Service Letter: 422 Revision "A" (Page 1 of 4)

Title: Aluminum Gear Retrofit

Models: Bellanca/American Champion 7ECA, 7GCAA, 7GCBC, 7KCAB, 8KCAB, 8GCBC

Description: Aluminum gear retrofit requires replacing the existing fairing tube, rerouting brake lines, and modifying the wheel pant cutout.

**Figure 1, 1-9998-1 Fairing Tube Installation**

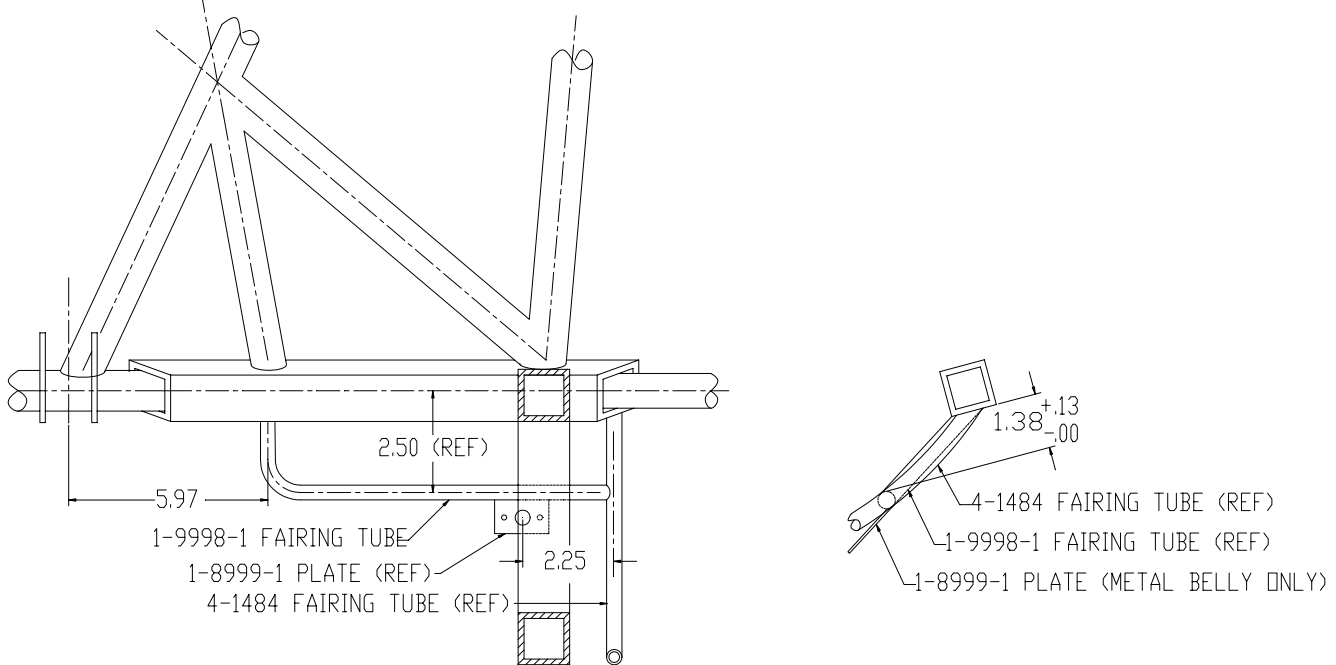
1. Refer to Service Manual for jacking of aircraft and procedure for removal of the old main landing gear leg assembly.
2. Remove fabric to expose 1-9998 fairing tube.
3. Remove 1-9998 tube, cut and grind flush to fuselage frame and 4-1484 fairing tube.
4. Grind 1-9998-1 tube to mate with fuselage frame.
5. Install 1-9998-1 tube per figure 1, weld per Champion Specification CW-1 or other industry accepted process for tubular steel welding.

6. If metal belly installed, install 1-8999-1 plate per figure 1, weld per CW-1 or other industry accepted process for tubular steel welding.
7. Treat all bare surfaces with zinc-chromate primer or equivalent.
8. Patch fabric and repaint in accordance with applicable ACAC service manual.

**Figure 2, 3-1498 Skin Cutout**

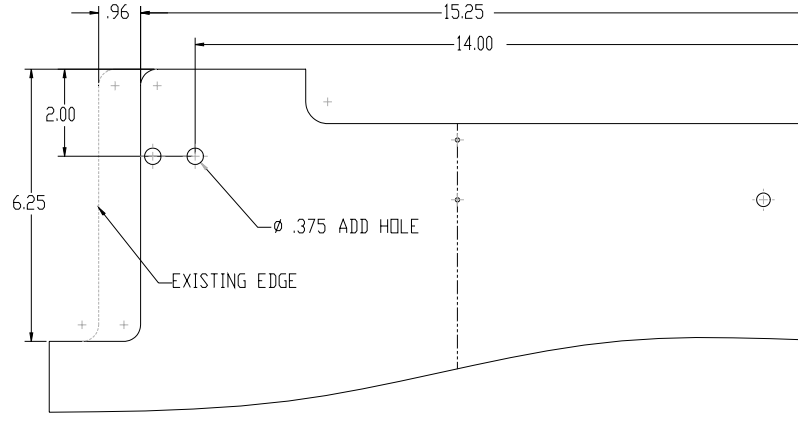
9. If metal belly installed, modify 3-1498 skin per figure 2.

**Figure 3, 2-2111-9 Brake Line Installation**

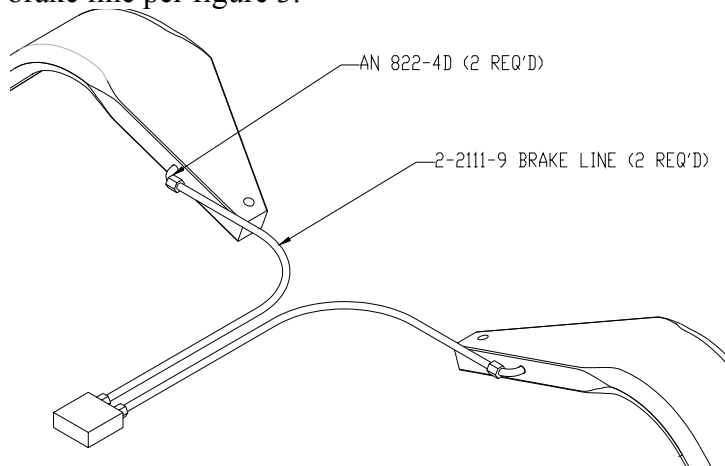
- 10. Install aluminum gear legs per ACAC drawing 7-1559 (no rev. or later) for all models except 8GCBC, for 8GCBC install per ACAC drawing 7-1579 (no rev. or later).
- 11. Remove 2-2111-8 (7-Series and 8KCAB) or 2-2133-2 (8GCBC) brake line and hardware and install 9563K84 snap plug in boot cowl.
- 12. Install 2-2111-9 brake line per figure 3.

**Figure 4, Wheel Pant Cutout**

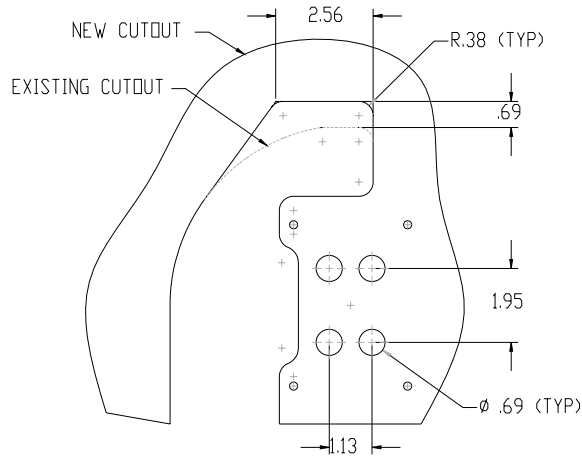
13. Modify wheel pant (Part Number 7-1541 L/R) per figure 4.
